# Modification Recommended Service Note

Supersedes:  
MSOS104A-03D

## MSOS104A – MSO Infiniium S Series 1GHz 4 channel

Serial Numbers: MY00000001 - MY58060101; SG54360101, SG55020101, SG55020102, SG55510101 to SG55510111, SG57130101, SG58060101, SG58060102, SG58150101 to SG58150106

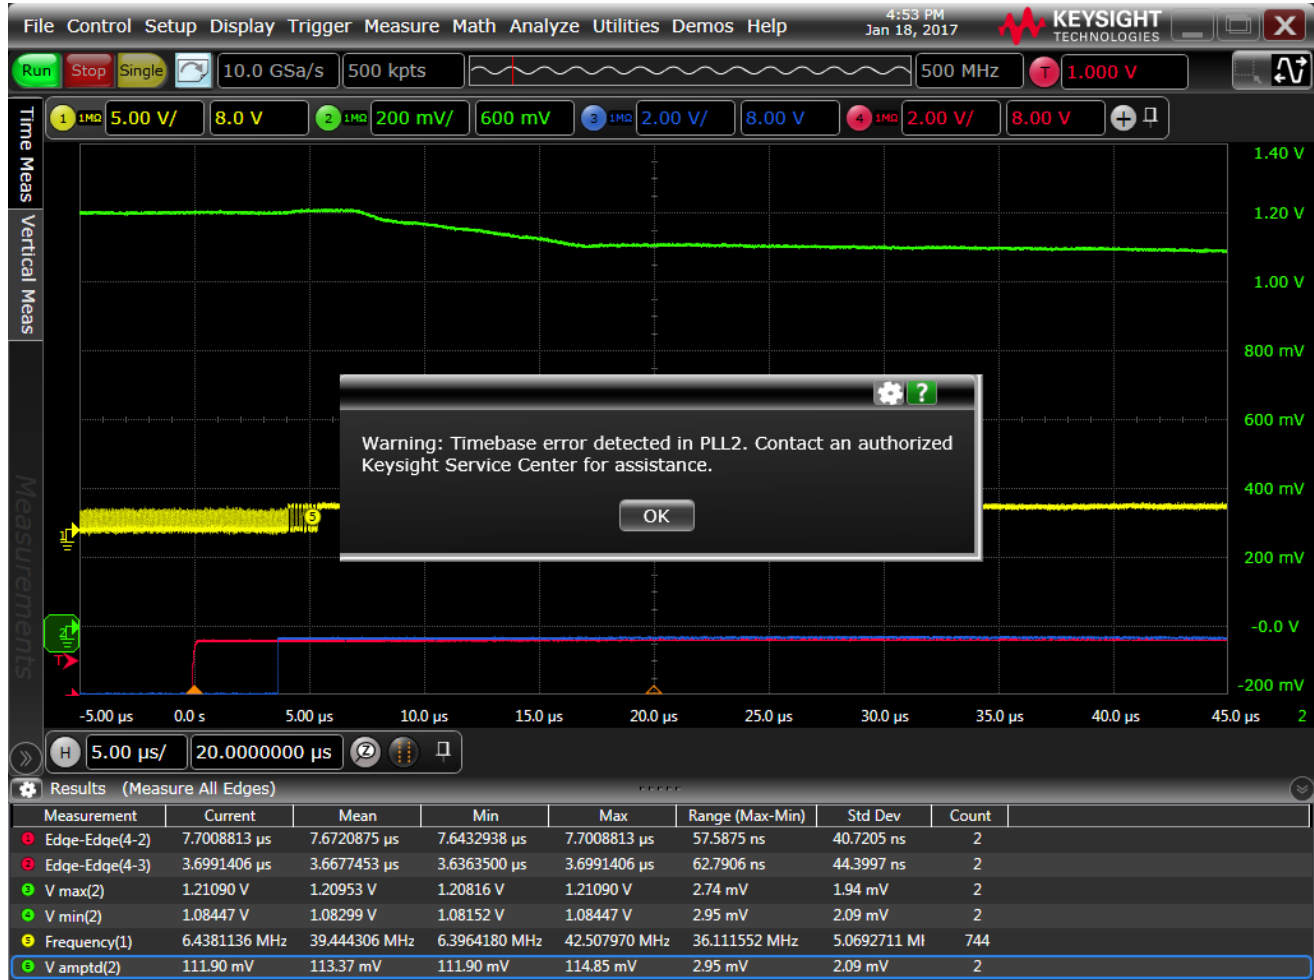
The Problem – Under certain circumstances a PLL2 error may occur on the S-series products.

On older acquisition boards a PLL2 error message sometimes occurs. The error message appears on the screen as below:

There are new acquisition boards that fix this issue for the S-series scopes.

Please, use the 54911-69511 board until is gone.  
If you have a 54911-69511, then skip steps 1 and 2 and proceed to step 3.  
If there are no 54911-69511, then start with step 1 below.

1. If the customer needs to have software revision < 6.10.01001, then replace the acquisition board with the 54911-69532 board.
2. If the customer can have software revision  $\geq$  6.10.01001, then it can be replaced by any of these three boards: 54911-69521, 54911-69531, or 54911-69532.
